ATTACHMENT 1

Revised St. Lucie Unit 2 Technical Specifications Pages:

## ATTACHMENT 2

#### Description of Change

FIGURE 3.4-2  
ST. LUCIE-2 P/T LIMITS, 6 EFY  
HEATUP AND CORE CRITICAL

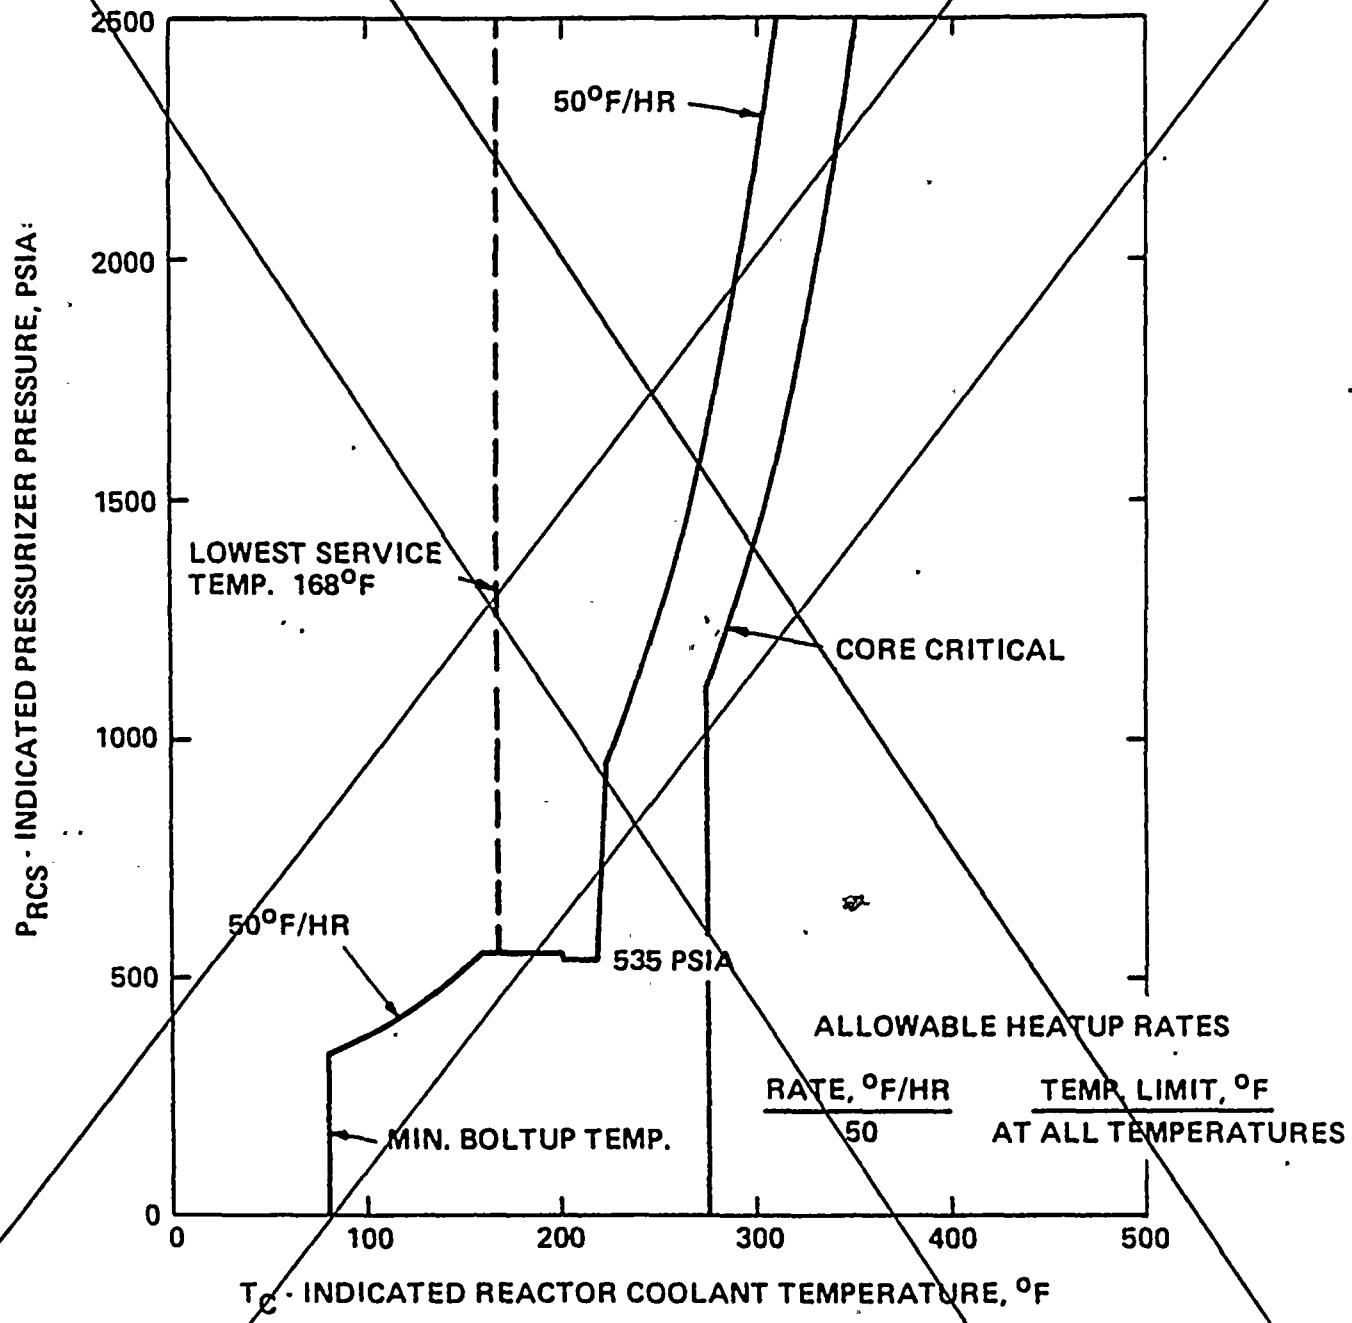
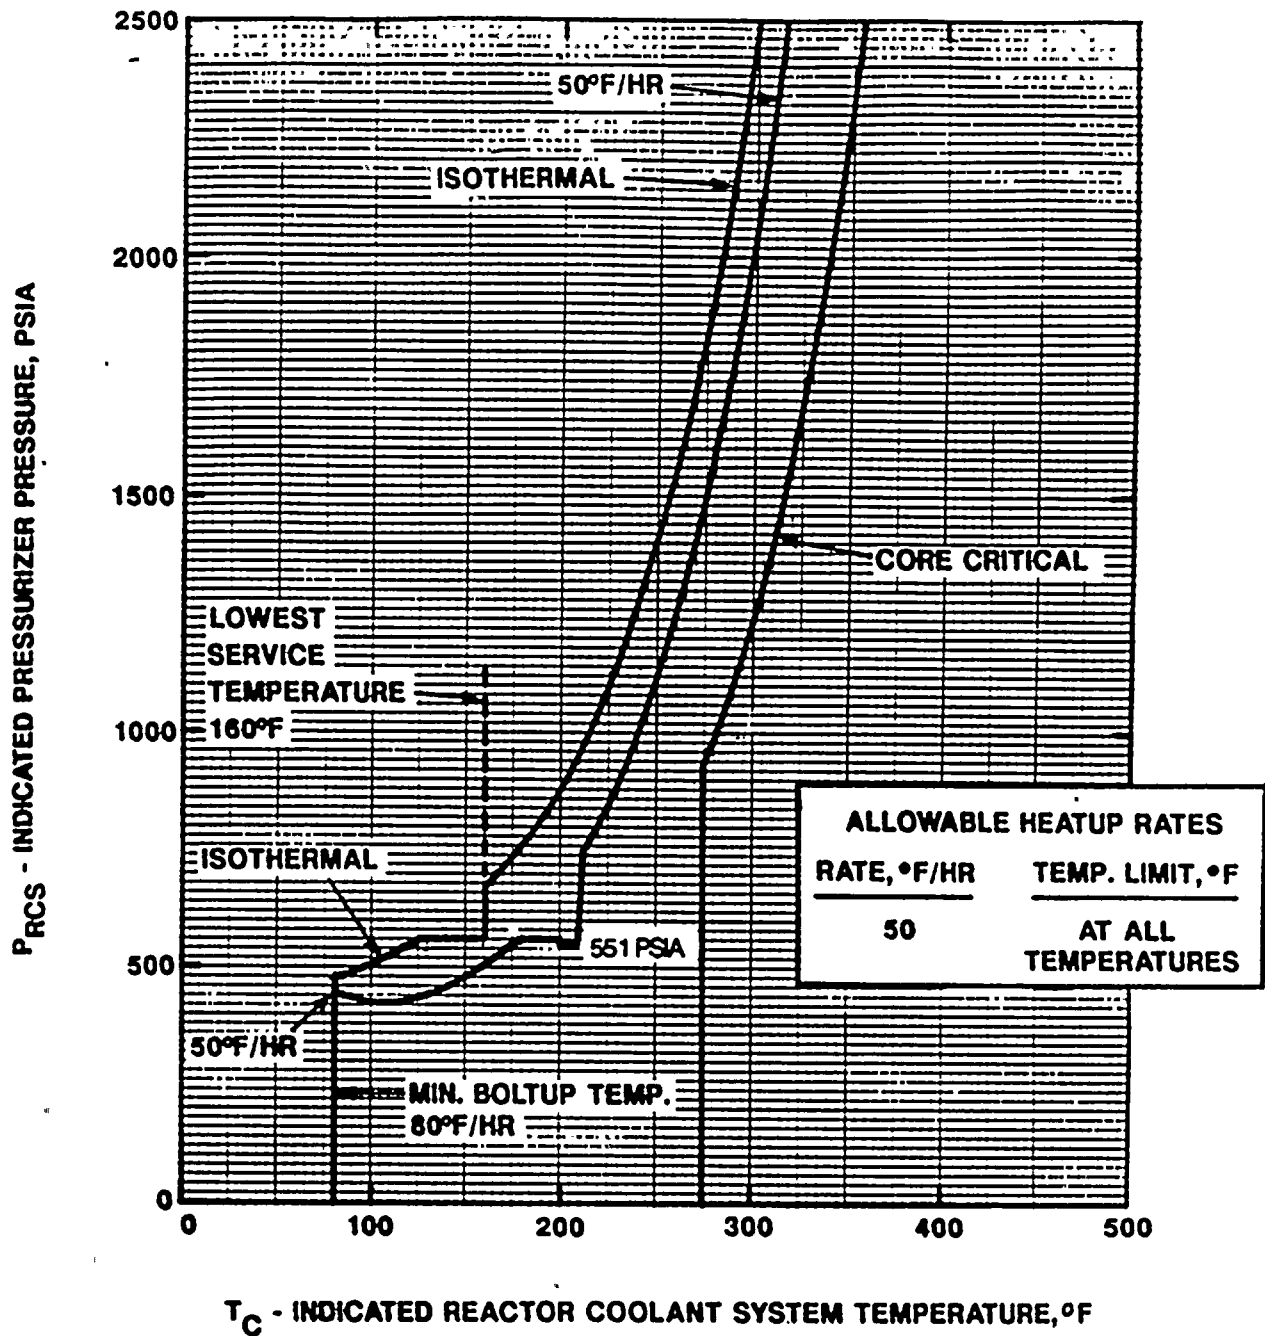
Delete, replace with  
attached new figure 3.4-2

- e. LCO 3.4.9.1 currently provides the pressure and temperature limits in terms of Figures 3.4-2, 3.4-3 and 3.4-4 of the RCS (except the pressurizer) during heatup, cooldown, criticality, and inservice leak and hydrostatic testing for 6 EFPY.

The proposed amendment would replace these three figures with three new figures, 3.4-2, 3.4-3 and 3.4-4 that are applicable for operation up to 15 EFPY.

FIGURE 3.4-3  
ST. LUCIE-2 P/T LIMITS, 15 EFY  
COOLDOWN AND INSERVICE-TEST

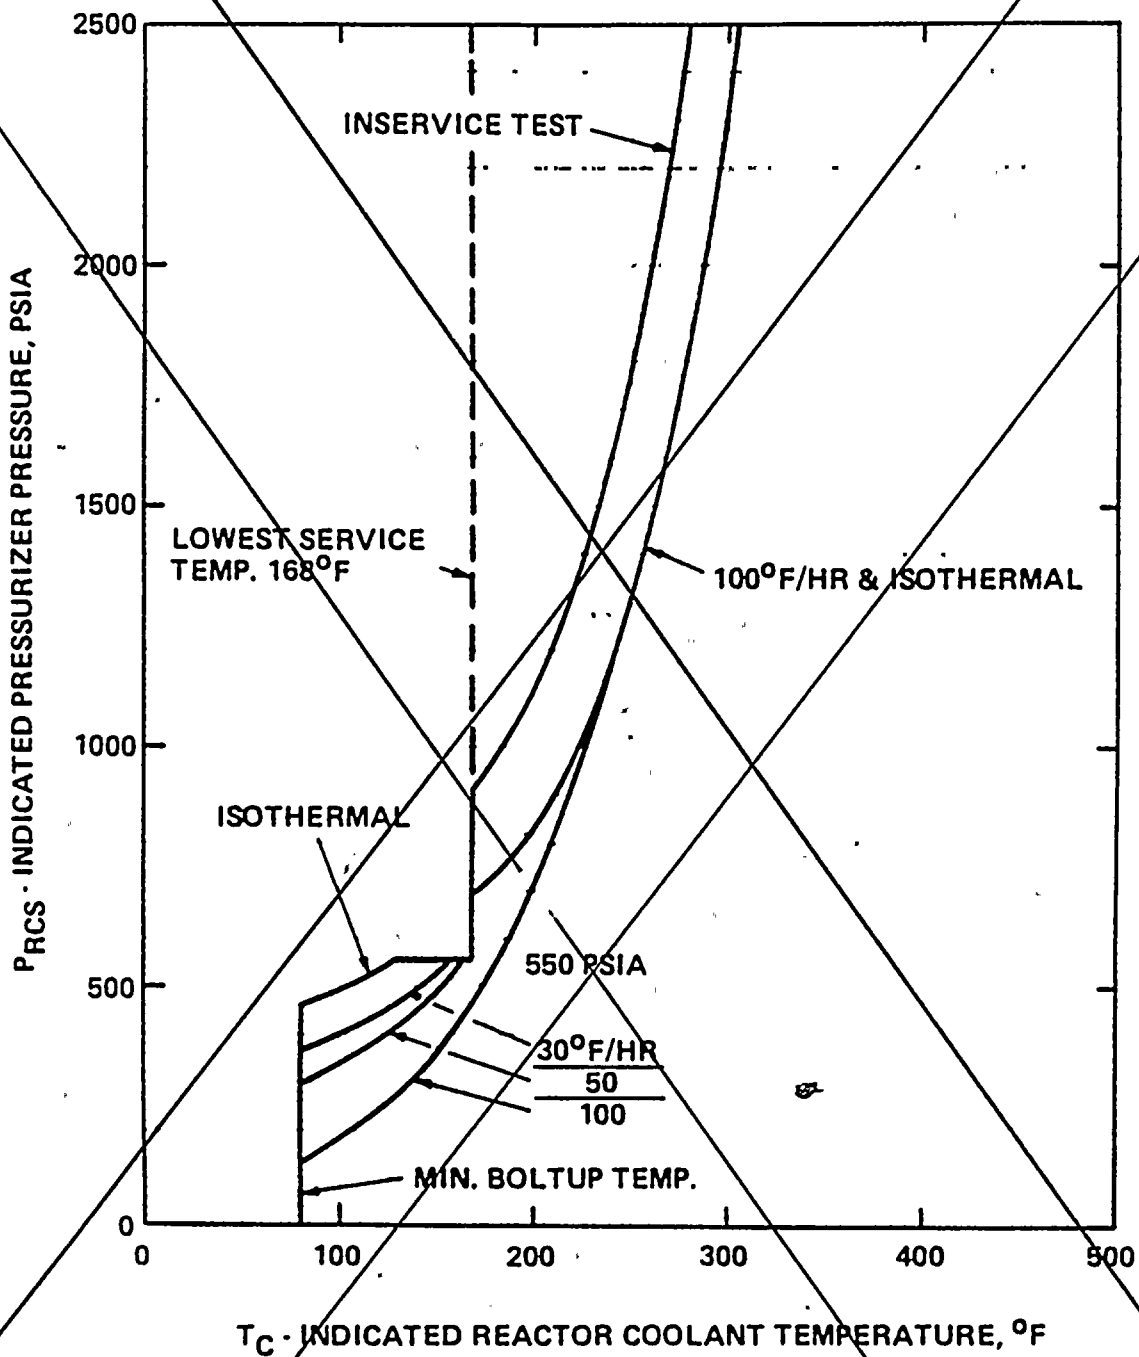
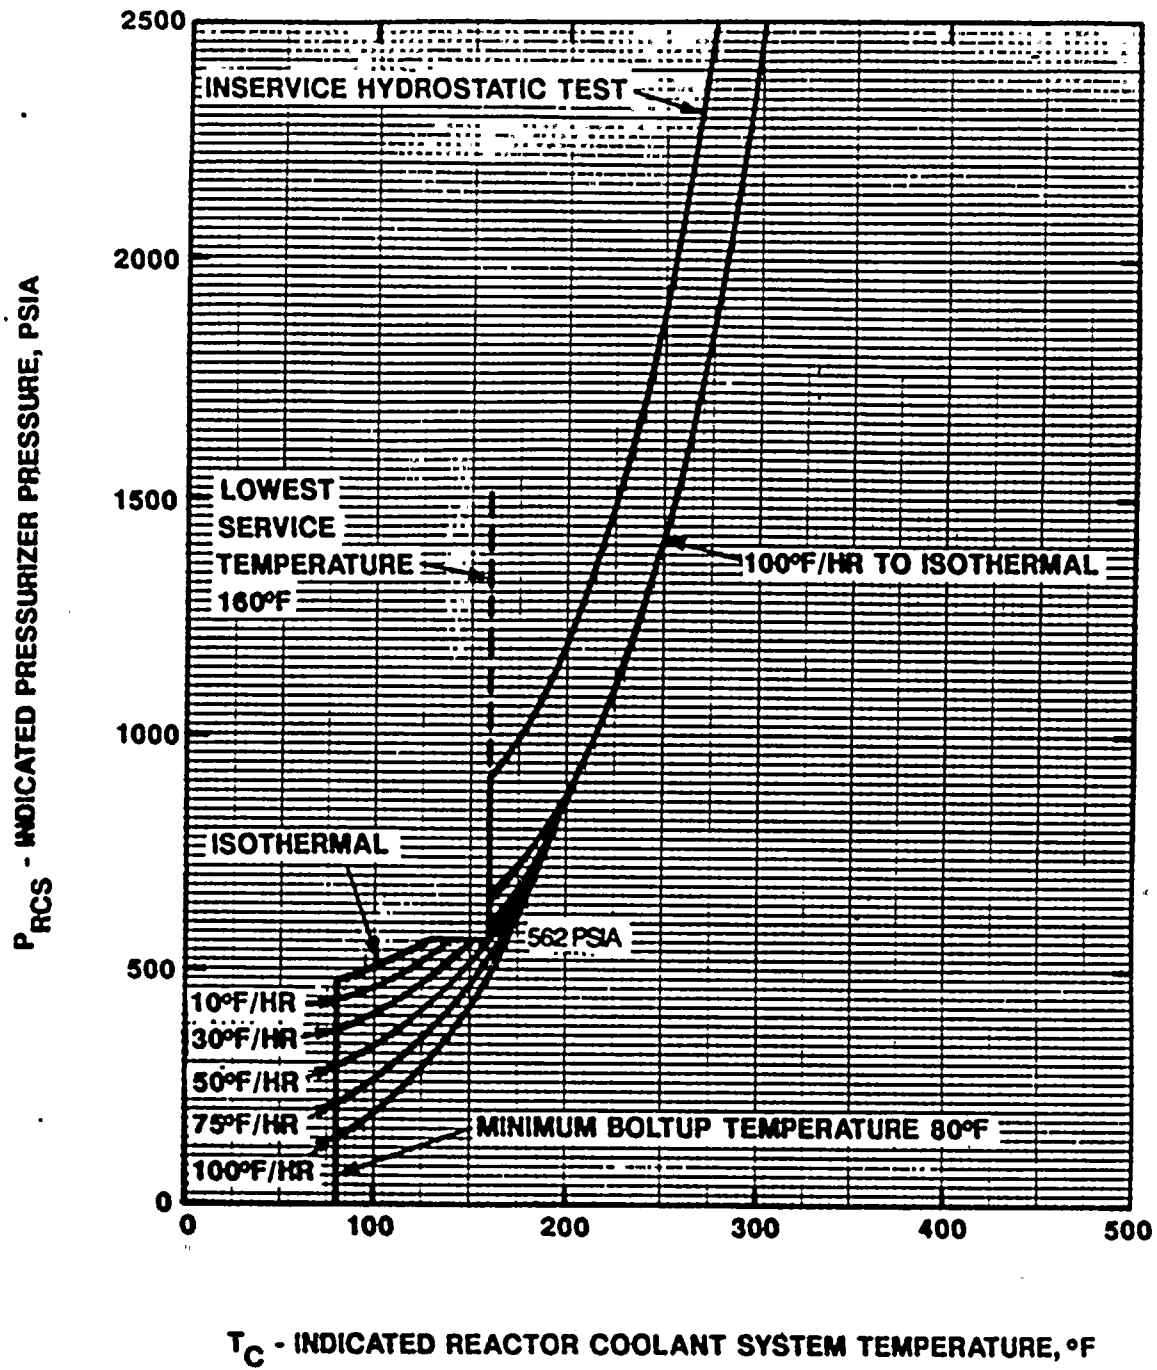
*Delete, replace with  
attached new figure 3.4-3*

**FIGURE 3.4-4**  
**ST. LUCIE-2 P/T LIMITS, 15 EFPY**  
**MAXIMUM ALLOWABLE COOLDOWN RATES**

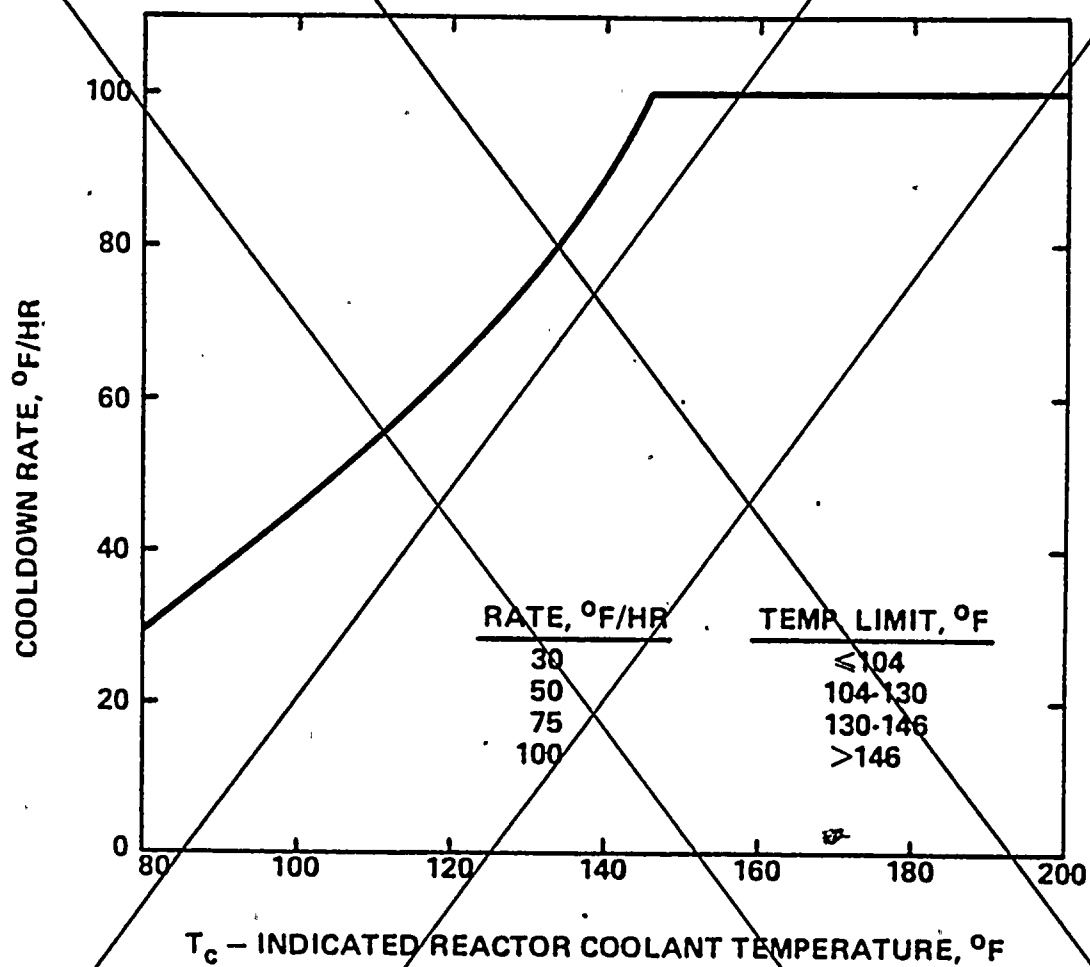
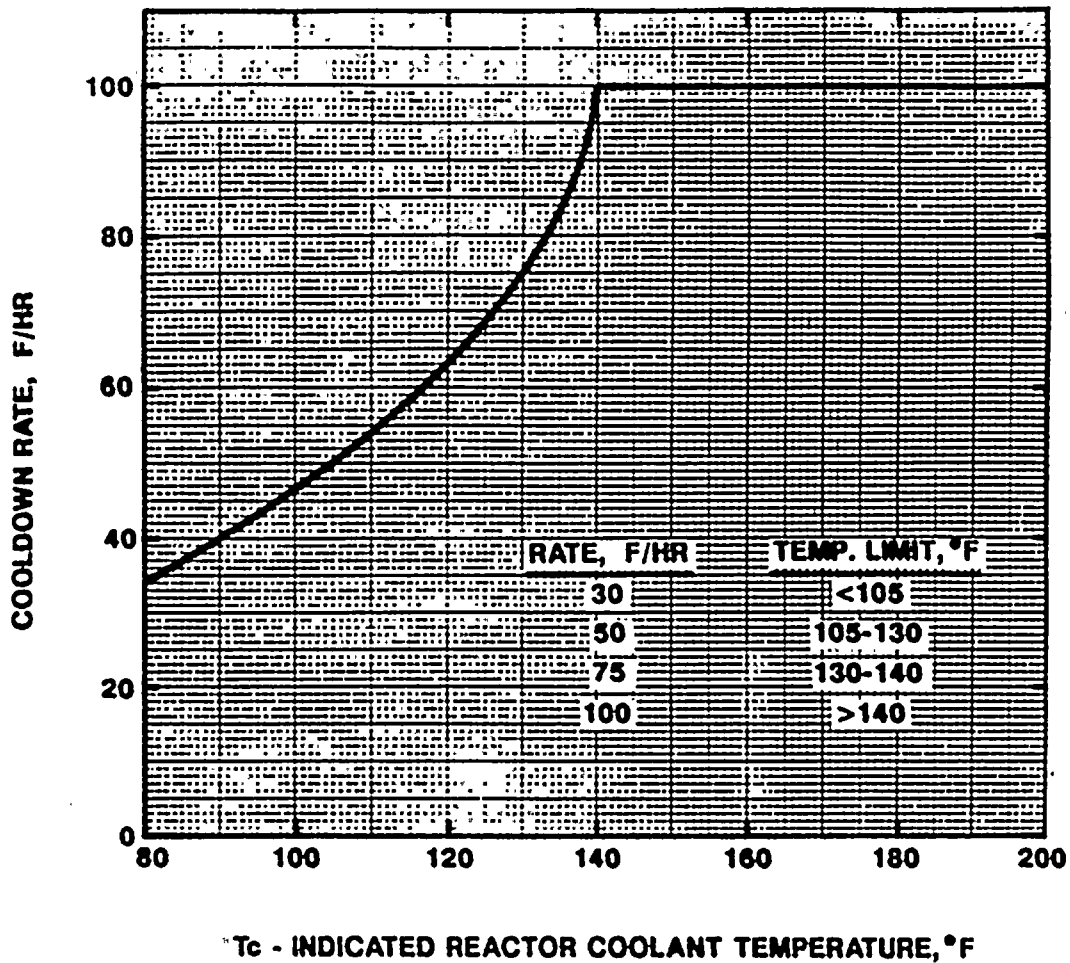
Delete, replace with attached  
new figure 3.4-4

TABLE 3.4-3

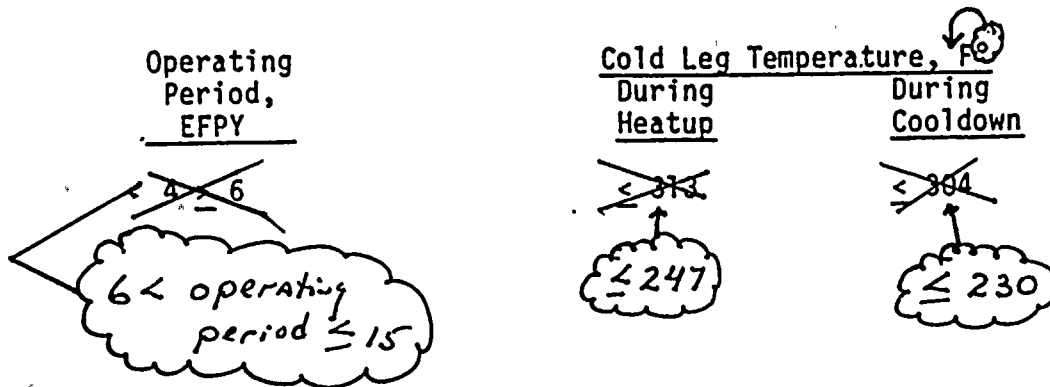
- h. Table 3.4-3 of LCO 3.4.9.3, "Low Temperature RCS Overpressure Protection Range" lists the enable temperatures during heatup and cooldown which indicate when LTOP is required. That is, during heatup, LTOP is required when the cold leg temperature is less than or equal to 313° F, and during cooldown, when the cold leg temperature is less than or equal to 304° F.

The proposed amendment would significantly reduce the LTOP range. The Table 3.4-3 would be revised to require LTOP with a cold leg temperature of less than or equal to 247° F during heatup and less than or equal to 230° F during cooldown. These new LTOP enable temperatures were determined in accordance with Standard Review Plan (SRP) 5.2.2 Rev. 2.

TABLE 3.4-4

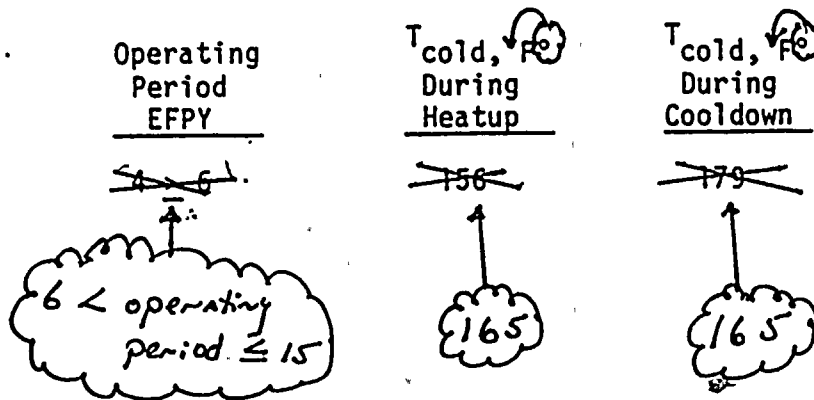
- i. Table 3.4-4 of LCO 3.4.9.3 "Minimum Cold Leg Temperature for PORV Use for LTOP" lists the minimum temperature that either two power operated relief valves (PORVs) or a PORV in conjunction with one shutdown cooling relief valve (SDCRV) can be used for LTOP. The minimum cold leg temperature is currently 156° F during heatup and 179° F during cooldown.

The proposed amendment would revise Table 3.4-4 to indicate the minimum cold leg temperature for PORV use for LTOP as 165° F during heatup or during cooldown.
